LOT 23 WILLERBURN ACRES

ADMINISTRATIVE SUBDIVISION PLAN NO. 620220010

Administrative Subdivision Plan to create a two lot subdivision to allow the construction of two single-family detached dwellings in the R-90 zone.

MCPB

Figure 6 - Tree Variance Exhibit

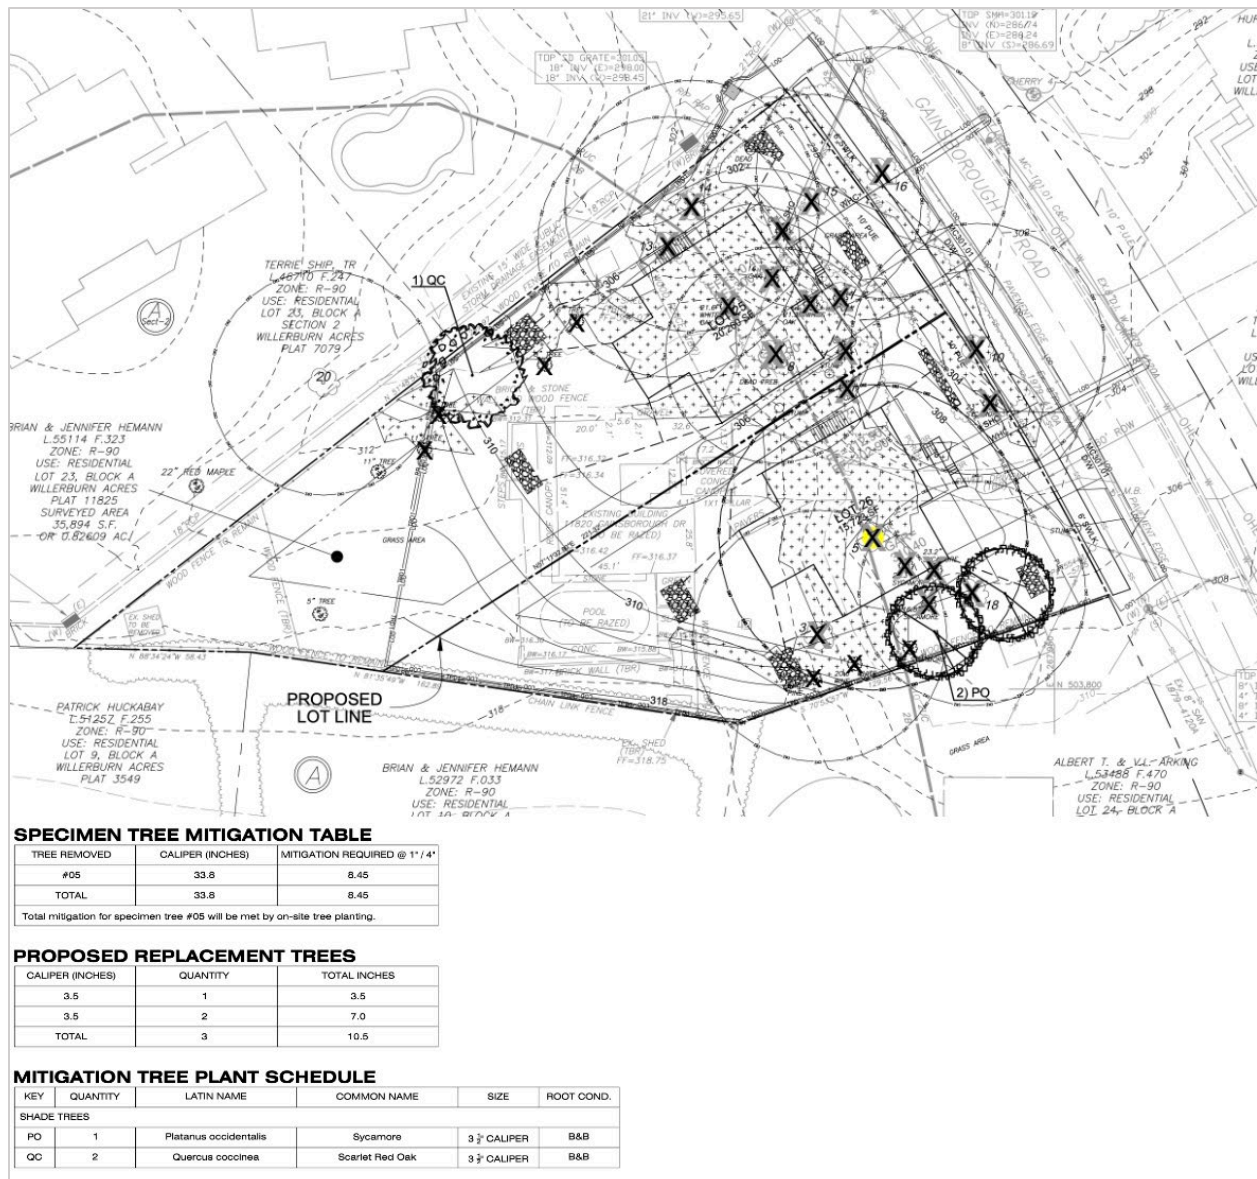
The Applicant submitted a variance request in a letter dated March 21, 2022 (Attachment C). The Application proposes to remove one (1) tree that is 30 inches or greater DBH, that is considered high priority for retention under Section 22A-12(b)(3) of the County Forest Conservation Law (Table 1).

Tree ID	Species	DBH	Reason	Status
#5	Tulip Tree (<i>Liriodendron tulipifera</i>)	33.8"	House construction and grading	Remove tree

As shown on the Forest Conservation Plan and the attached Tree Variance Exhibit, Tree #5, a Yellow Poplar (*Liriodendron tulipifera*), has a 33.8" diameter at breast height. It is located at the southeast quadrant of the Property. The tree is located on a steep slope adjacent to the existing driveway to the north. In order to preserve this tree, there would be a great loss of buildable area on the site. In addition, the type of tree and health of the tree do not make it a good candidate for preservation. There is observed damage/ decay to the trunk (possible cavity), top damage, and poor branching.

Justification: The specimen tree #5 is in an undesirable location within the property making any plans for development infeasible. The tree is not in good health – there is observed damage/ decay to the trunk (possible cavity) and the top of the tree, poor branching, and pruning is needed. Yellow Poplars are notorious for soft wood and branches that will fall due to storm damage. This tree is not providing such benefits to the Property as to outweigh the potential of the new development which includes proposed trees, as well as putting back into productive use a site that is vacant today.

ADMINISTRATIVE SUBDIVISION PLAN

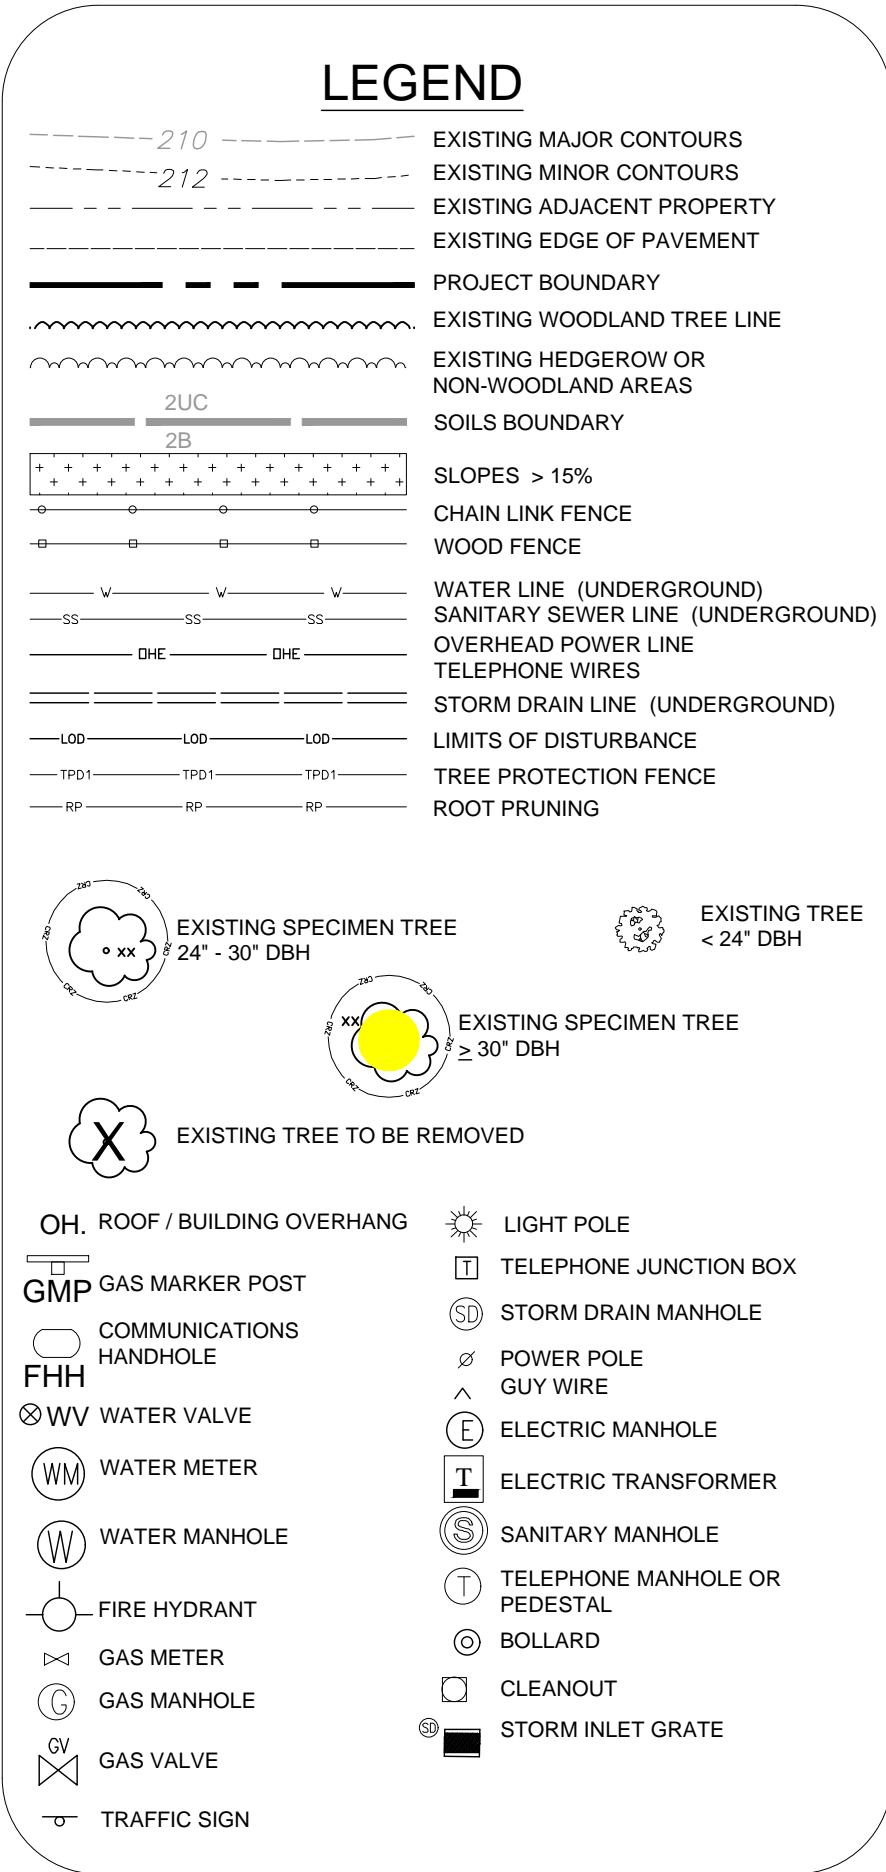
1. Provide a six (6) foot wide, concrete sidewalk along the Gainsborough Road frontage.

FIRE DEPARTMENT
ACCESS PLAN

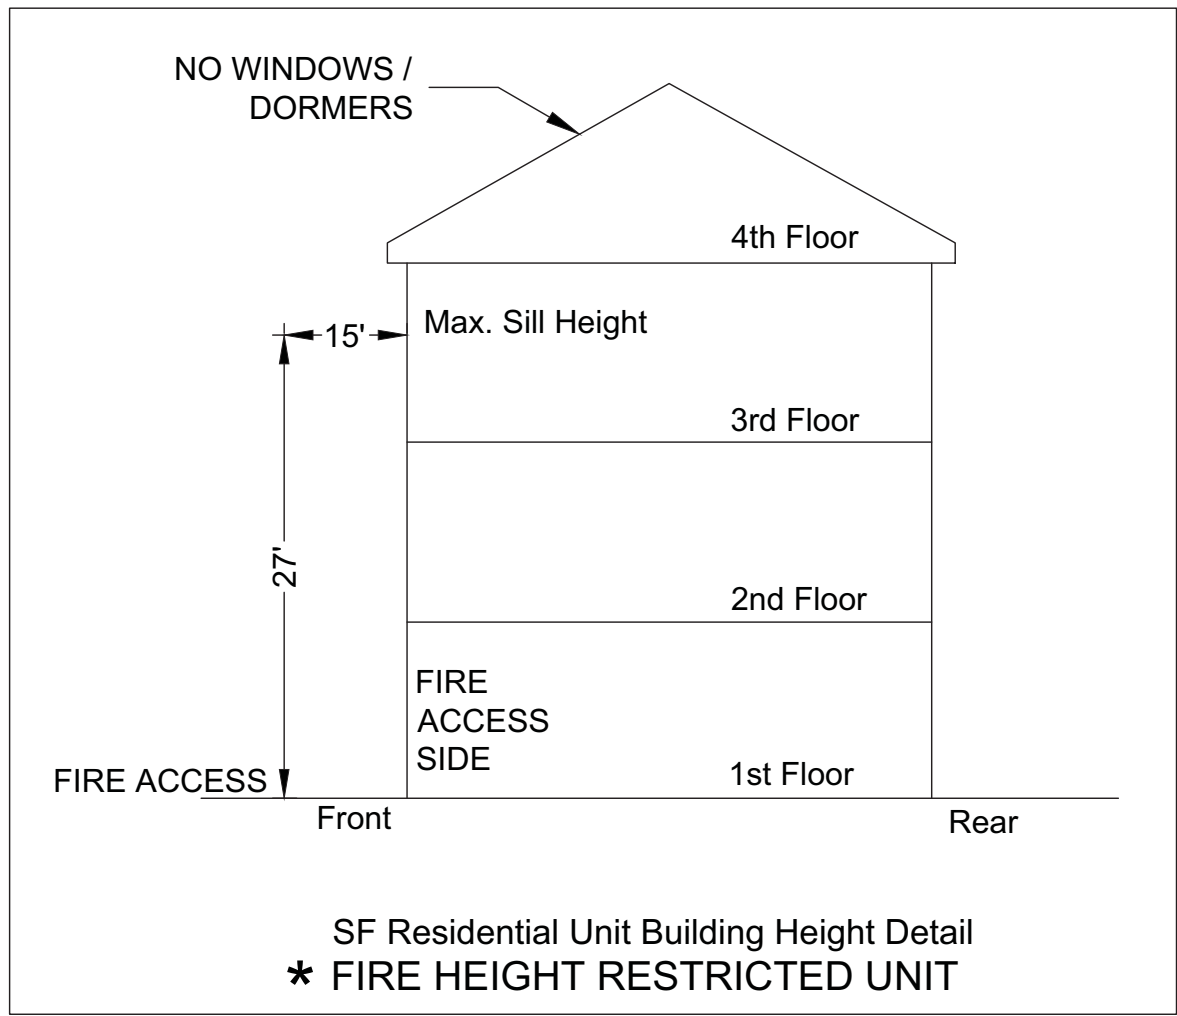
1. Review based only upon information contained on the plan submitted **05-May-22**. Review and approval does not cover unsatisfactory installation resulting from errors, omissions, or failure to clearly indicate conditions on this plan.
2. Correction of unsatisfactory installation will be required upon inspection and service of notice of violation to a party responsible for the property.
